HERMAN MASSEY PARK
1002 N FRANKLIN STREET, TAMPA, FL, 33602
HARDSCAPE - PAVING PLAN

SHEET:
LH-101

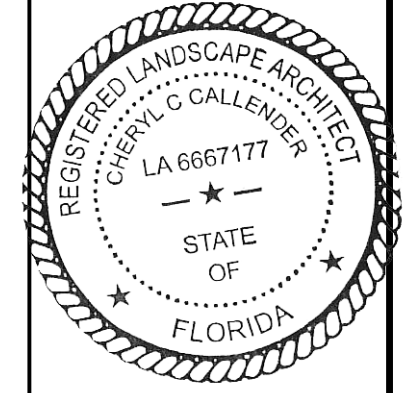
Bid Alternate 3
Simplify synthetic turf and permeable paving layout

Bid Alternate 2 (-47 SF)
Change granite pavers to colored, exposed aggregate concrete to match seat wall (P16), reduce banding width from 48" to 42"

Bid Alternate 1 (8,198 SF)
Change decorative concrete to natural concrete with light broom finish; change joints to saw cut at 7' o.c. and orientation to match deck pavers; include expansion or construction joints as necessary along this orientation, maintain 6" thick section with reinforcing per detail;
